Town Council Meeting

October 10, 2022 at 6:00 PM Howey-in the-Hills Town Hall 101 N. Palm Ave., Howey-in-the-Hills, FL 34737

Consideration and Approval: (First Reading) Ordinance 2022-019 - Reserve/Hillside GrovesDevelopment - PUD Amendment

- 4. Consideration and Approval: Appointment of Alan Hayes to the Planning and Zoning Board
- 5. Consideration and Approval: **Howey Self Storage Final Site Plan Submission**
- 6. Discussion: Retired Landfill Historic Overview
- 7. Consideration and Approval: Fencing around Town Lift Stations in Central Park and Griffin Park

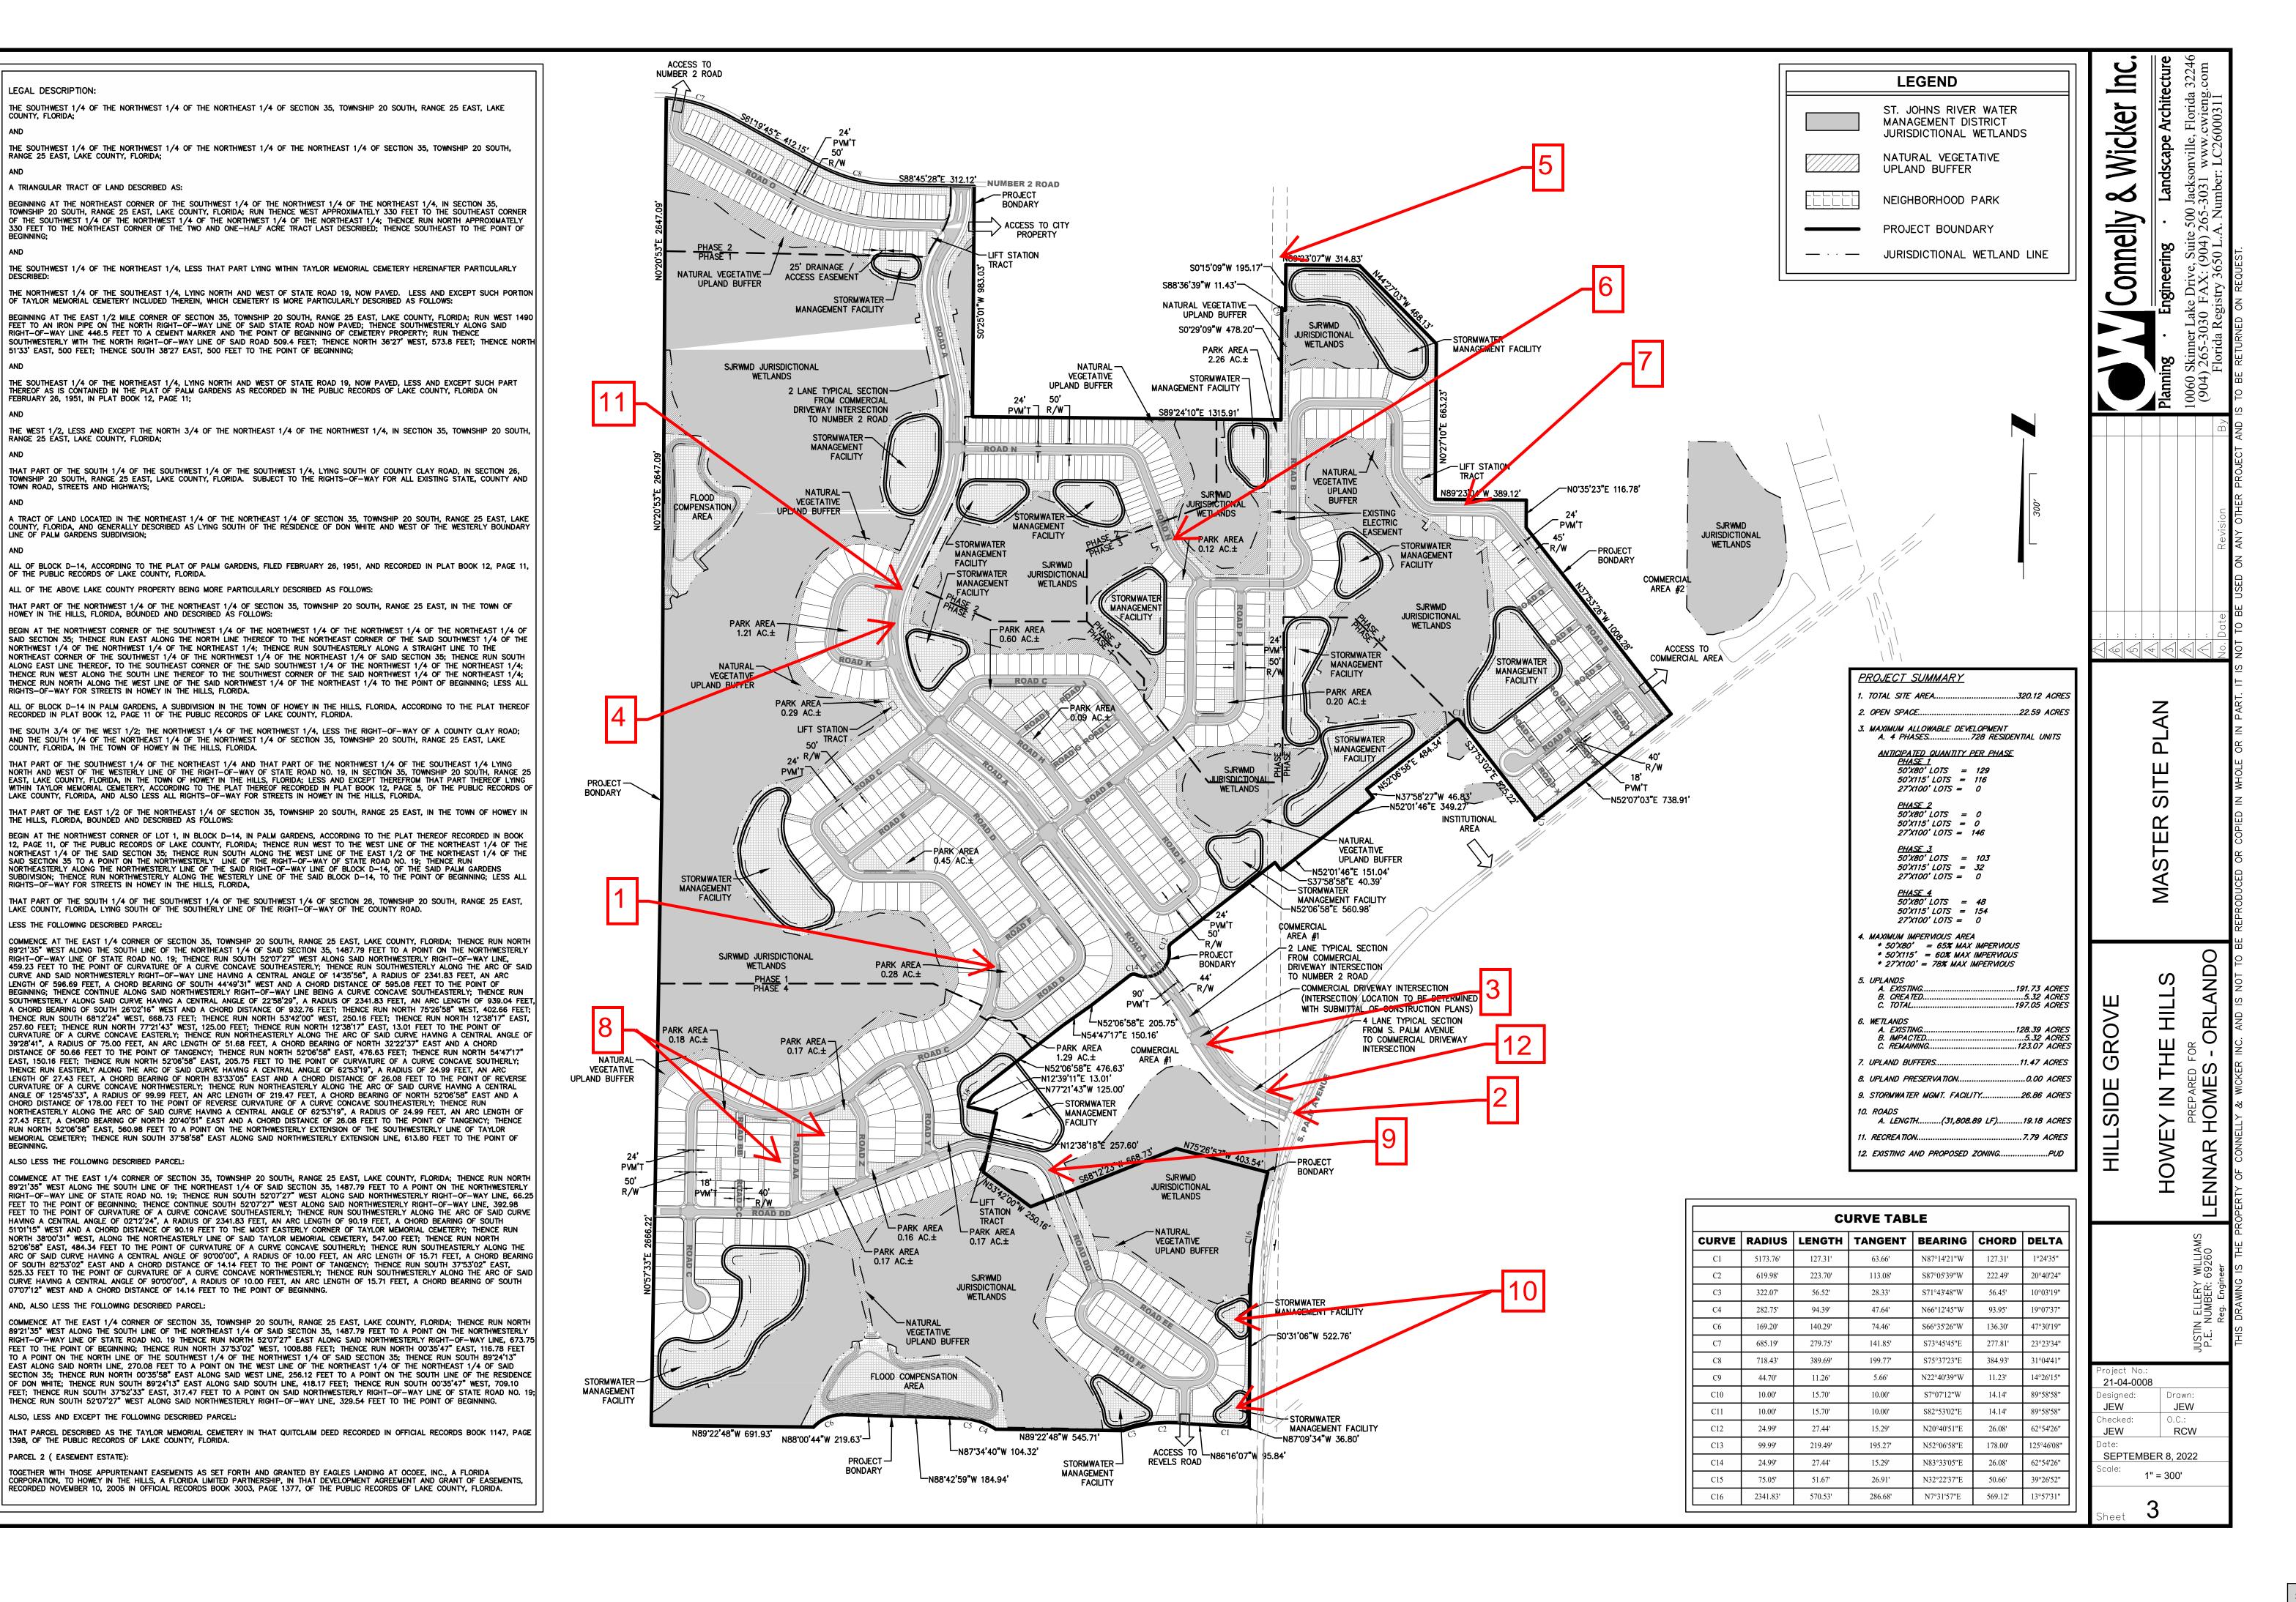
In addition to the above items, we submit the following summary of the revisions on the attached redlined Master Site Plan from the original approval PUD exhibit. The project has now begun detailed engineering design and a greater level of detail is now shown. Each number below corresponds with a number listed in red on the Master Site Plan

- 1. The roadway alignment has been revised to create a safer condition for both pedestrians and vehicles.
- 2. The entrance roadway connection to S. Palm Drive has shifted south approximately 250'.

- 5. The emergency access adjacent to a stormwater pond at the north side of the project has been removed.
- 6. A roadway connection is added between phase 2 and phase 3 in lieu of a cul-de-sac in phase 2.

- 7. The driveway apron pictorially shown previously has been removed.
- 8. Lots are revised to be 50'x115' lots in lieu of 50'x80' lots.
- 9. A roadway connection is shown connecting all of phase 4 development.

- 10. Added stormwater management facility locations.
- 11. The phase line revised so that spine road connection to Number 2 Road is included in phase 1.

- 12. The right of way between S. Palm Drive to the project boundary is revised to be a 100' wide to allow for additional green space for tree plantings.
- 13. Other minor revisions that are a result of additional progress on detailed design that are not numbered but are identified here are:
 - a. Shifting of lot lines
 - b. Relocation of Pump Stations
 - c. Addition of Natural / Vegetative Upland Buffers
 - d. Pond banks and normal water lines more accurately depicted
